# CAMBRIDGE/LEXINGTON HOMEOWNER'S ASSOCIATION

This report notes background information, existing conditions, provides an analysis and makes recommendations concerning drainage patterns for two areas in the Lexington Addition. These two areas show conditions of poor drainage due to slow runoff and ponding of drainage water. In effect, these conditions have created tension among impacted neighbors and "finger pointing" as to who is responsible for the situation.

**RE: Backyard Drainage Runoff  
November 9, 1999**

FIGURE A

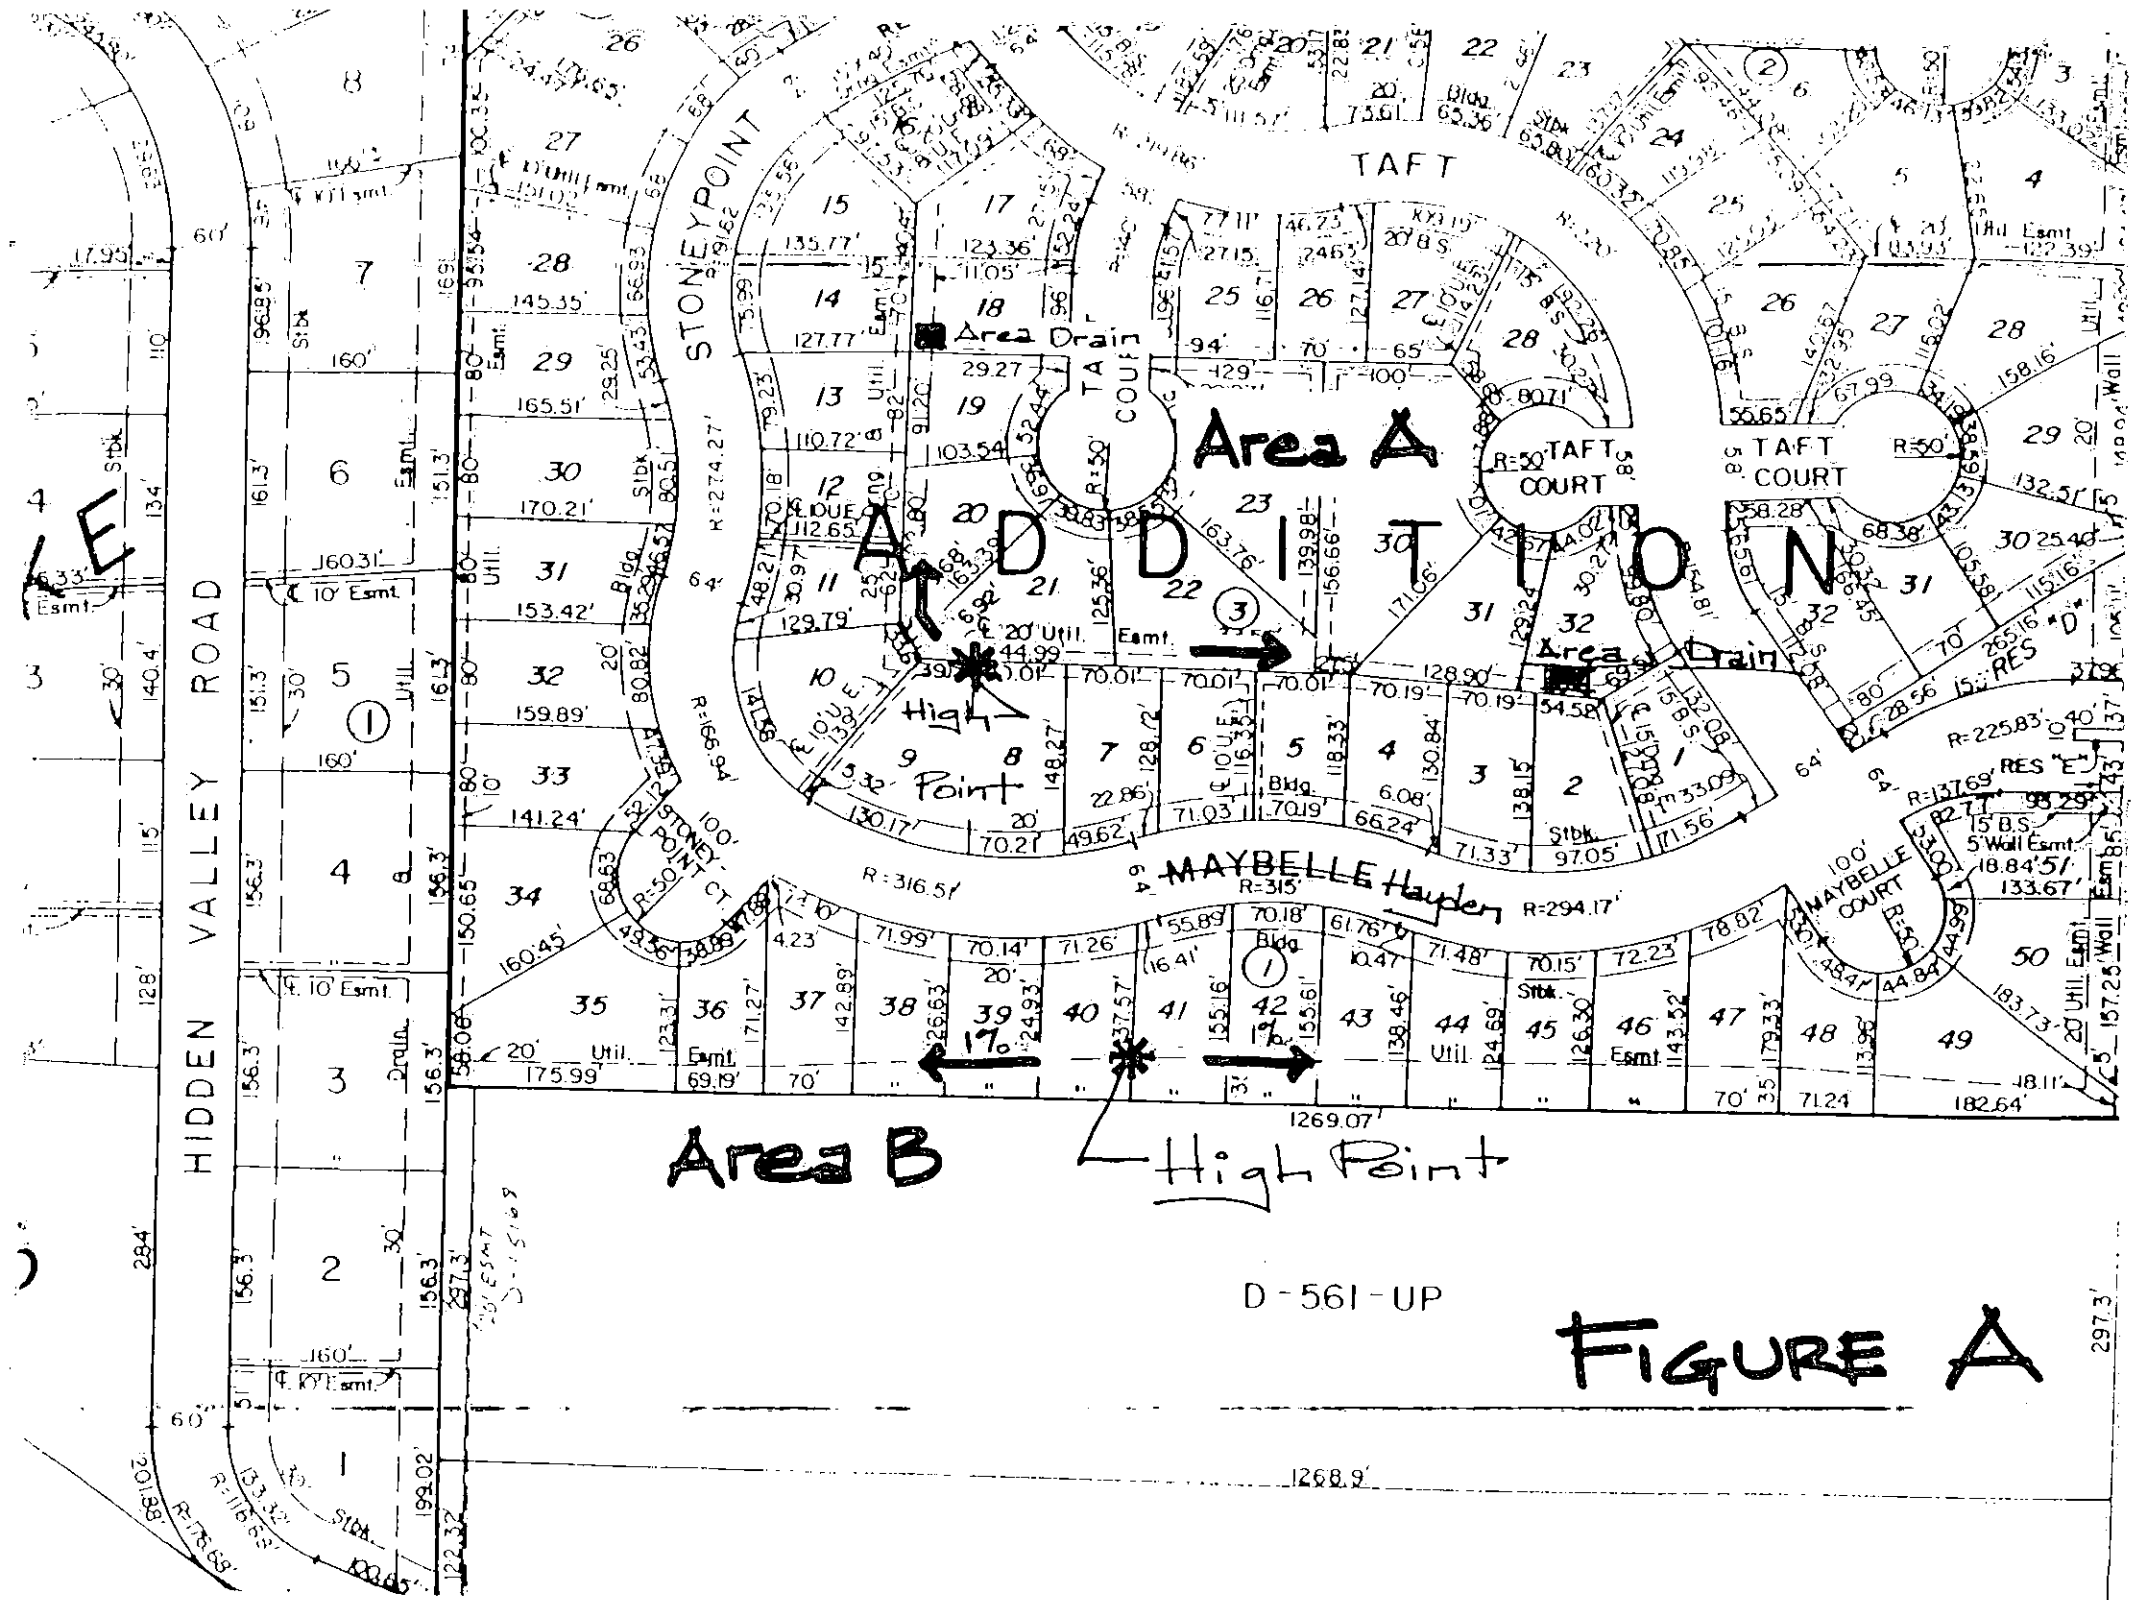
The plat and drainage plans for the Addition were prepared by Poe & Associates, Civil Engineers of Wichita. For Area A, the drainage plan exhibits a high point between lots 8 and 9. From the northwest corner of lot 8, drainage is designed to flow east at a 1% slope to an area drain at the rear of lot 32. Running northwesterly then north from the high point the drainage is designed to flow at a 1% slope to an area drain at the southwest corner of lot 18. For Area B, the drainage plan exhibits a high point between lots 40 and 41. Drainage flows east and west in a swale along the easement line north of the south property line. A 1% slope is designed for lots 36 thru 46 and lots 47 and 48 are slightly less at 0.85% and .84% respectively. At the time of original development, the drainage plan was designed to meet current City regulations. Recent revisions to the City's subdivision regulations require a 1% minimum slope for drainage runoff. Figure A shows the planned pattern of the drainage plan for these two areas.

FIGURE B

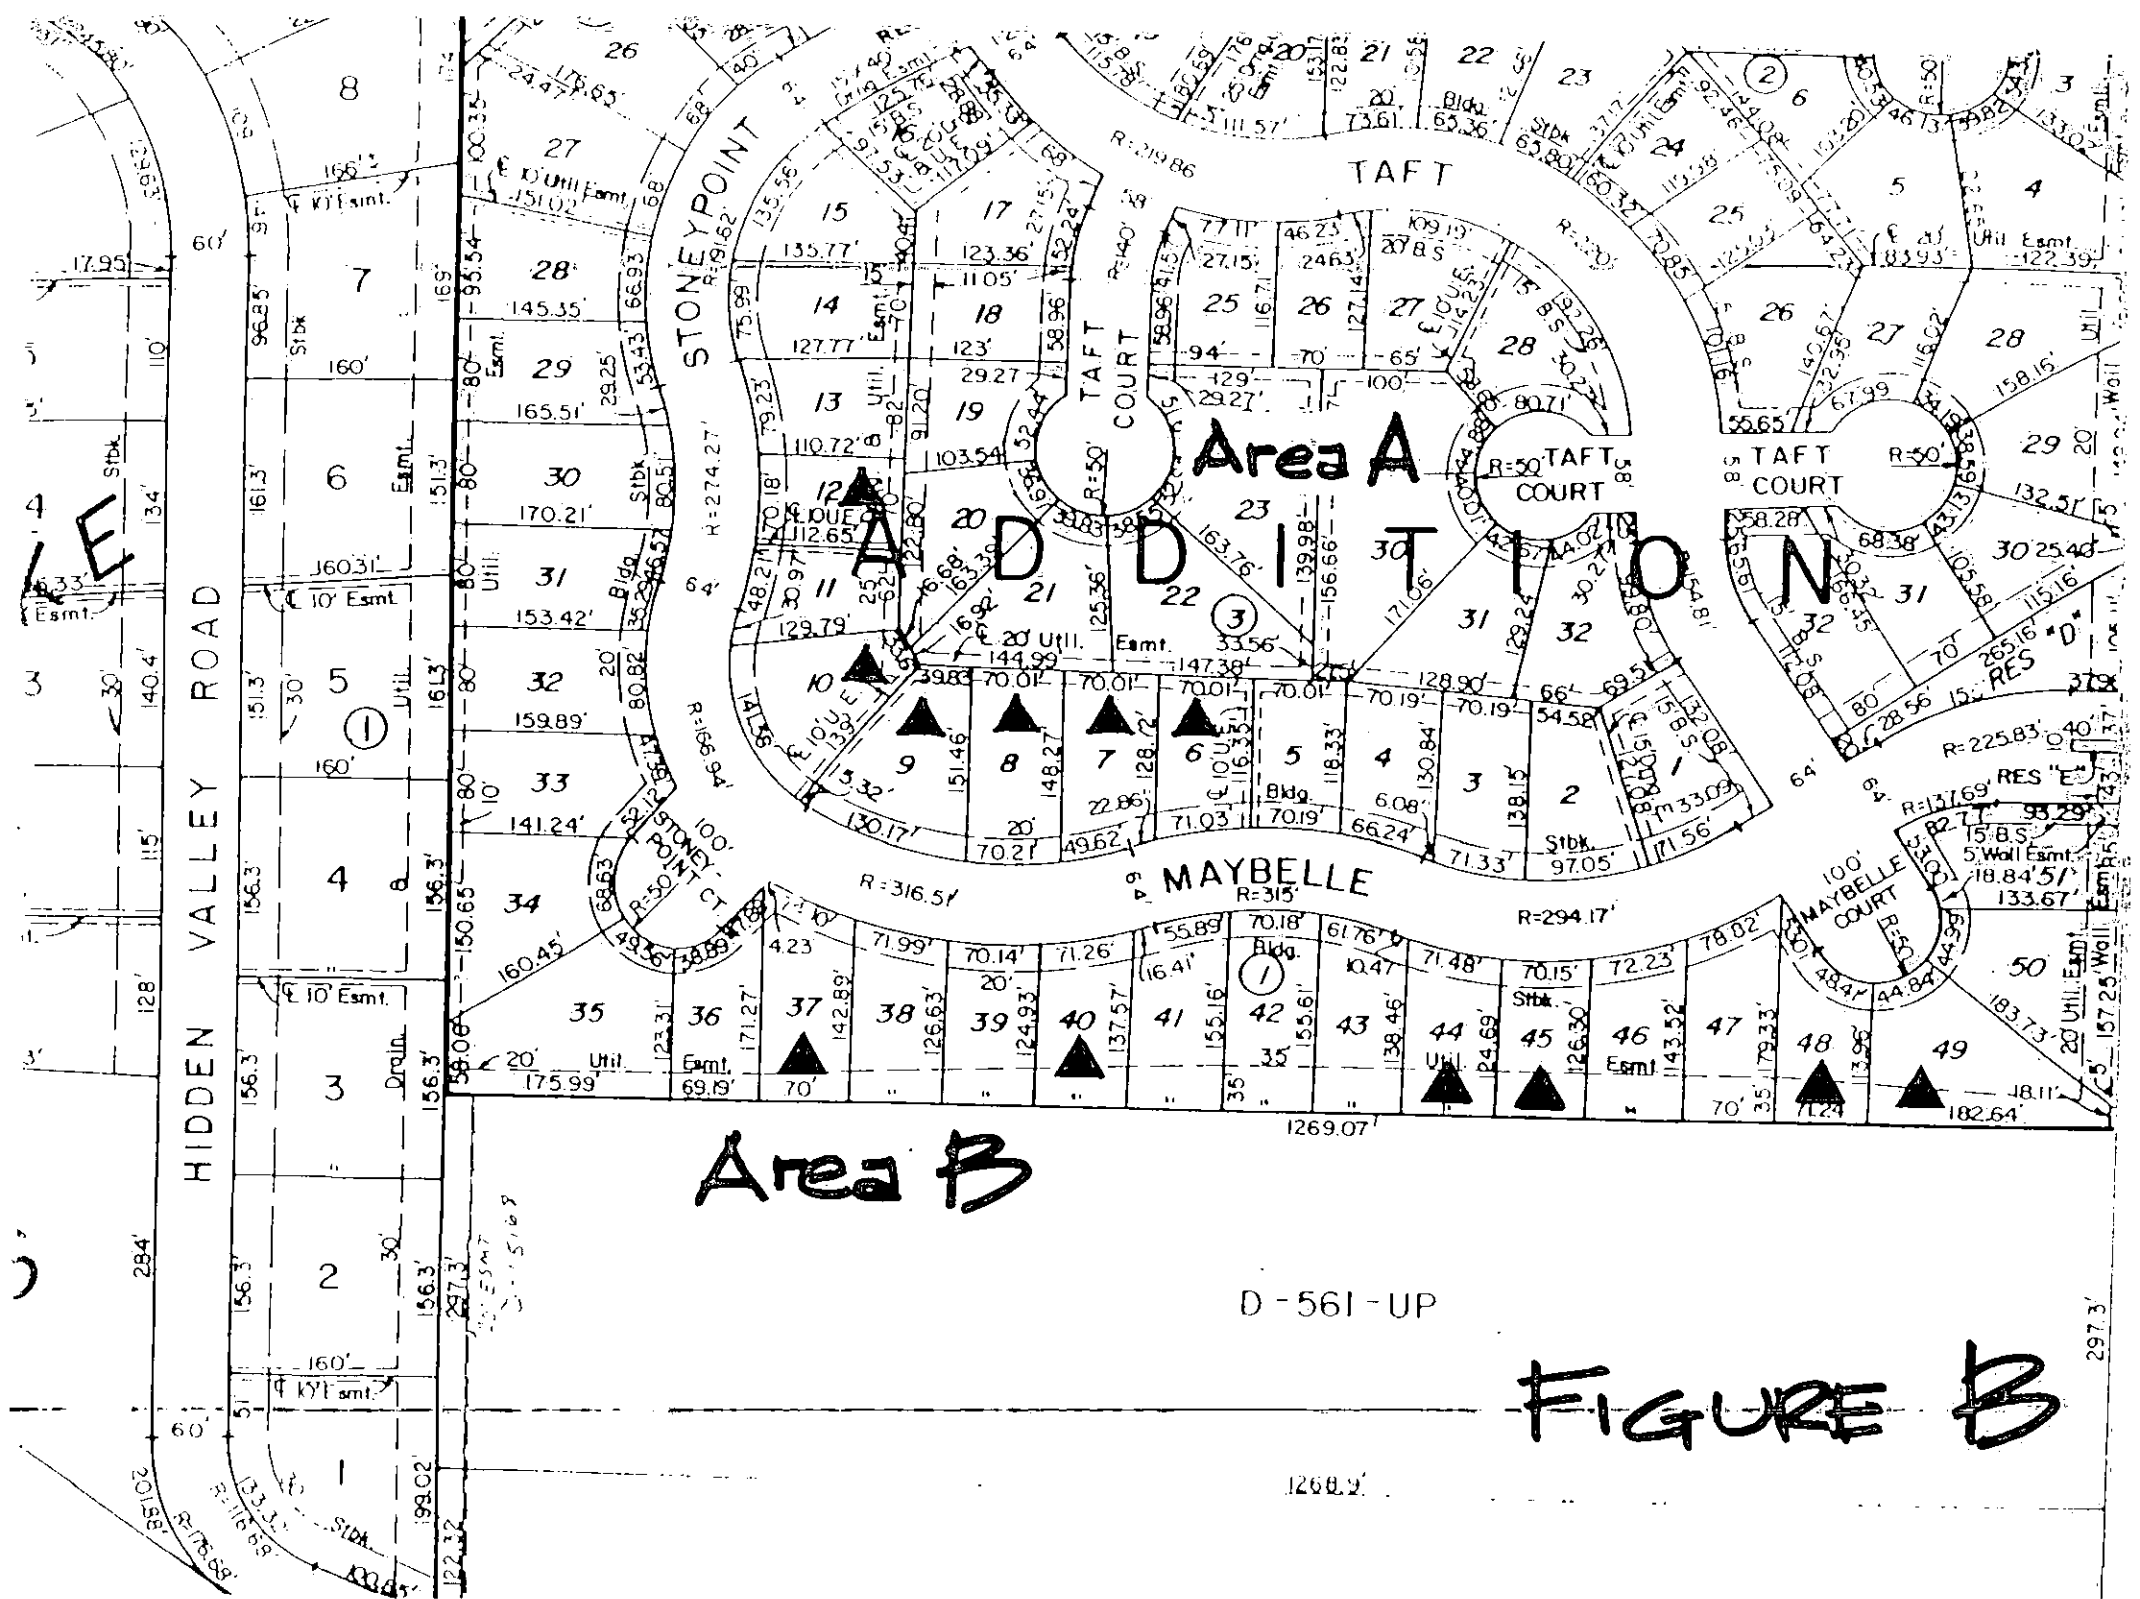
The varied slopes shown in the existing conditions indicates there are drainage problems. Most slopes less than 1.0 % and several flat areas will cause slow drainage and ponding. If the slopes are studied between existing conditions and the planned drainage it is possible to examine the problem more broadly. For area A, from the high point northward to the area drain on lot 18 there would be a 0.93 % if existing conditions in between were not considered. This is close to the planned drainage. Going east from the high point the drainage is only at 0.62% to the northeast corner of lot 5. Note that the grade shot there was taken at the general low point along the fence which would be the drainage flow once the soil is removed from the bottom of the fence. Further grade shots would need to be taken to relate to the area drain to the east.

For area B, from the high point west to the southwest corner of lot 37 the slope is 0.67%. If the slope is taken from the existing elevation at the southwest corner of lot 40 west to the same corner of lot 37 the slope increases to 1.05%. From the southwest corner of lot 44 to the southeast corner of lot 47 the slope is 1.02%. Further analysis such as this along with the sequence of grading work for lots could be done to understand why 1.0% grades were not achieved uniformly as planned. This would not be practical now because improvements exist which limit the possibility of going back and regrading the subdivision throughout all of these problem areas.

While it would be ideal to regrade the problem areas to conform to the drainage plan it is not practical due to the improvements along rear lot lines made by homeowners. These improvements include grass, irrigation systems, swimming pools, fences and ornamental landscaping. It is important to note that all of these improvements were made by homeowners following grading and drainage work established by the builder. Due to the improvements in place, it is recommended that a system of area drains and French drains be implemented to solve the drainage problems of all lots which stand water after rains or irrigation use and have slope gradients of less than 1%. Figure B exhibits these lots. This work will require minor regrading and repairs to irrigation systems, lawn areas and perhaps damaged utility lines. To avoid adverse impact to adjacent lots by dumping drainage water from effected lots, it is recommended that underground drain pipes be extended to the area drains in place. Slopes of 2% minimum are recommended for regrading to new area drains and French drains on lots.
